- Wiltshire councils SFRA which is the online arcgis, live version of the document has flooding maps that show the extent of flooding based on historic floods rather than modelled estimates.

- Despite the EA requiring a main modification in the current core strategy for Warminster that a SFRA 2 for the town be done due to the complex nature of flooding and the unknown interactions of various flood sources and topography, or the capacity and effectiveness of current flood management infrastructure to cope with current demands on it, let alone those increases due to climate change, this has not been done.

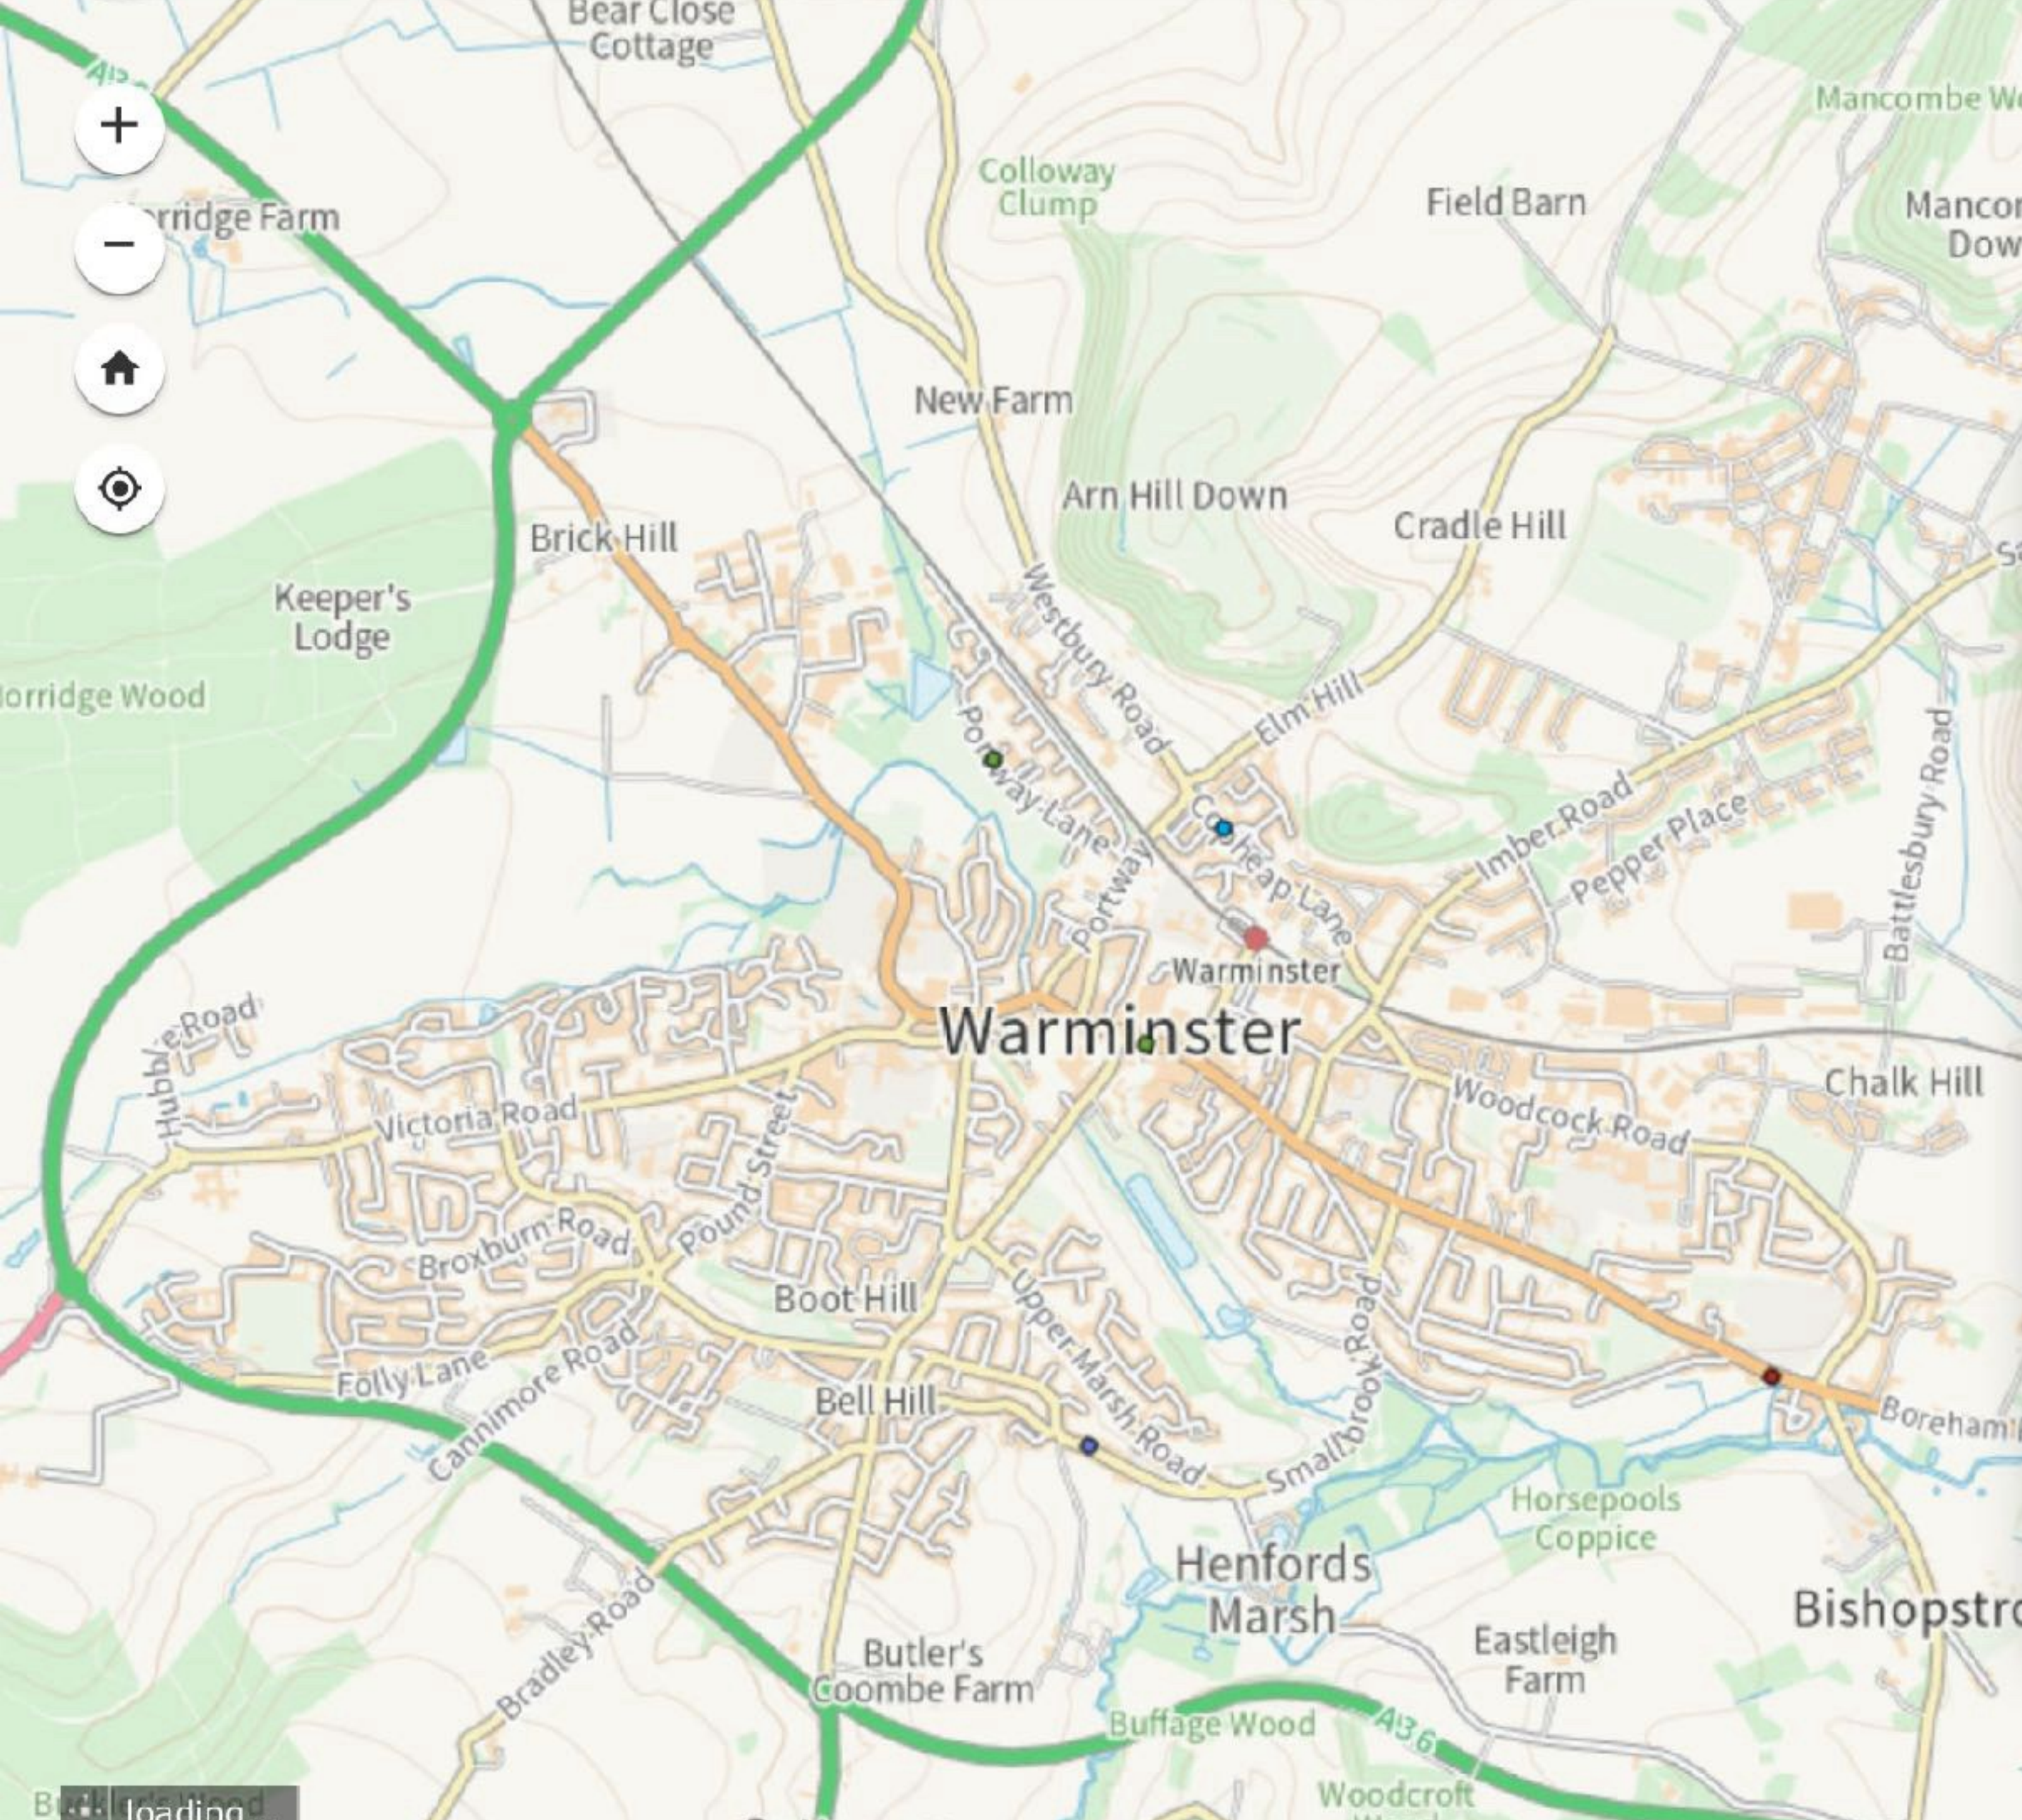
- As is evident on the above map, the extent of flooding from surface water, and historic events is clearly marked and looks extensive which would ensue that planning officers assessed their plans in line with known flood issues in these areas, helping to make sound decisions on developments, flood risk infrastructure weaknesses, pinch points, vulnerable areas and possible flood storage areas for heavily effected sites.
- Using these details along with site specific fra documents helps ensure that the infrastructure required to manage flood risk now and going forward is front and centre in decision making, and CIL spending, and helps to highlight if the in combination effects of all flood sources may be overwhelming flood infrastructure before costly floods occur.

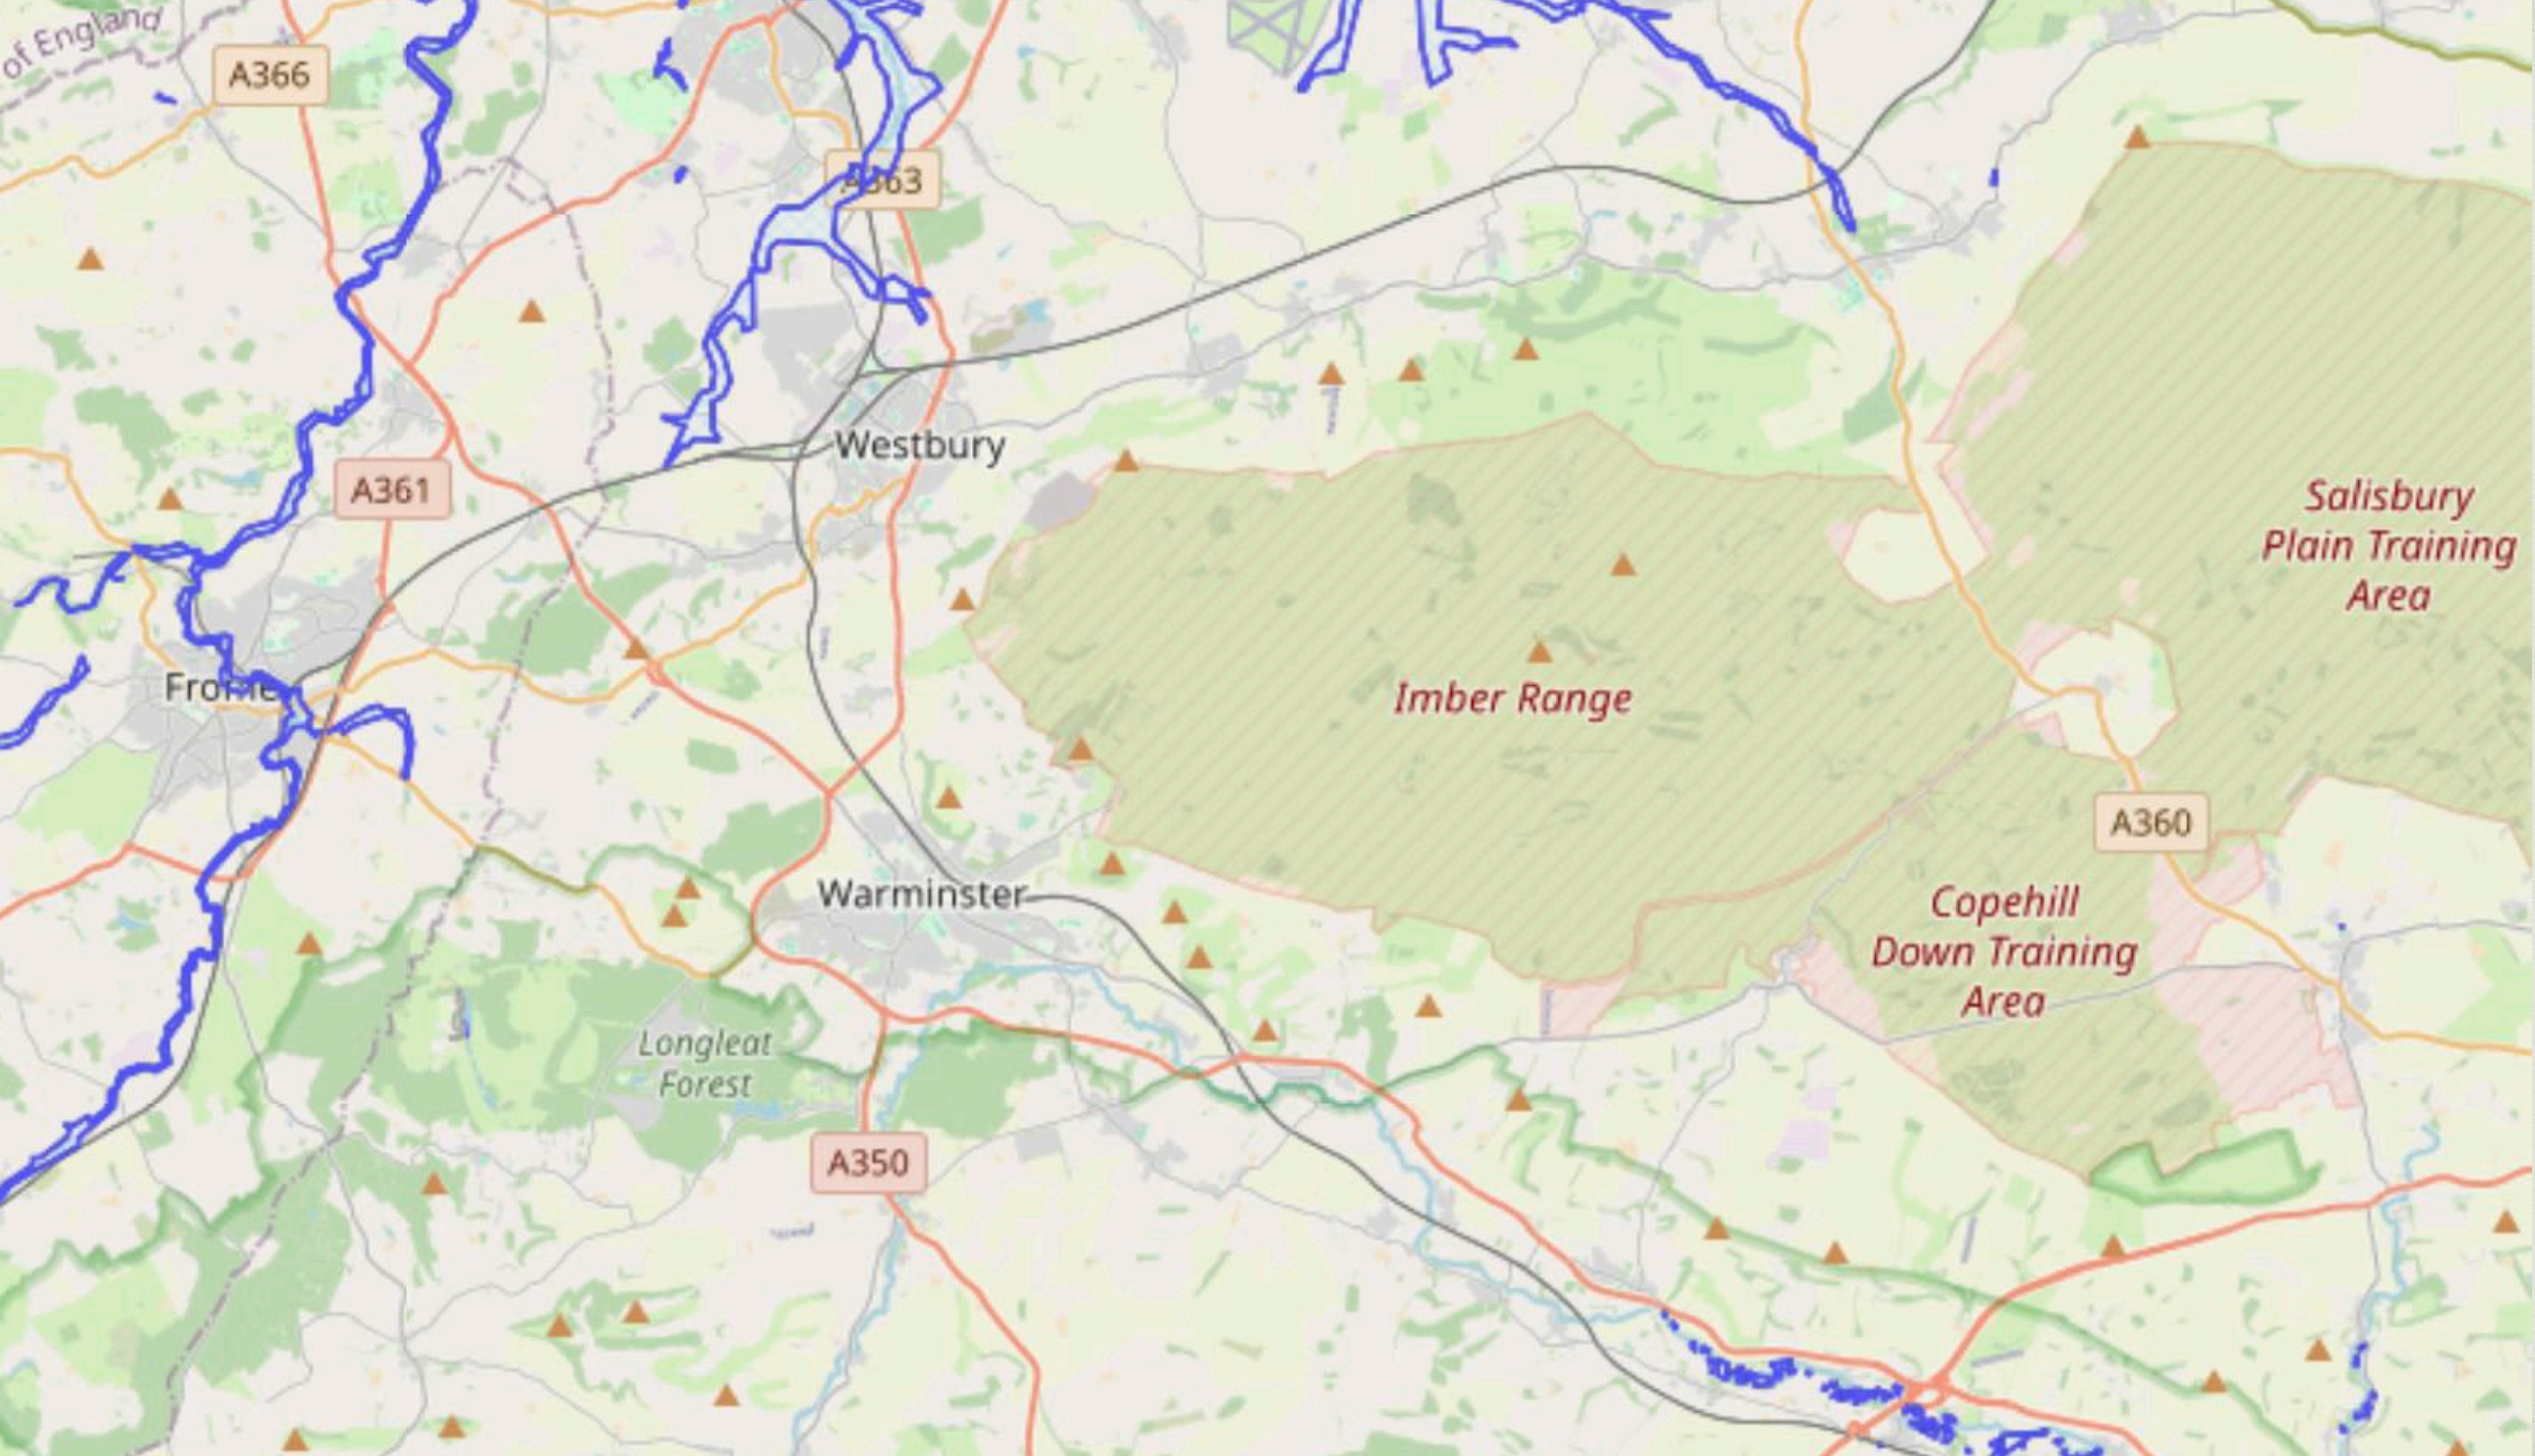
- The above map is the DEFRA version of the SFRA and it is also missing all flood data from Warminster so neither the EA or county council, or developers are using accurate up to date flood risk information.

- The EA and council have been provided pictures, dates, extent of flooding but never add it to the system, why?
- Despite this total lack of data and know repeated flood events, shown in newspapers, on Facebook, town council flood event reports dating back to 2015 neither the council nor the EA have required specific flood policies for Warminster that reflect this dangerous lack of data. Instead it is not mentioned.
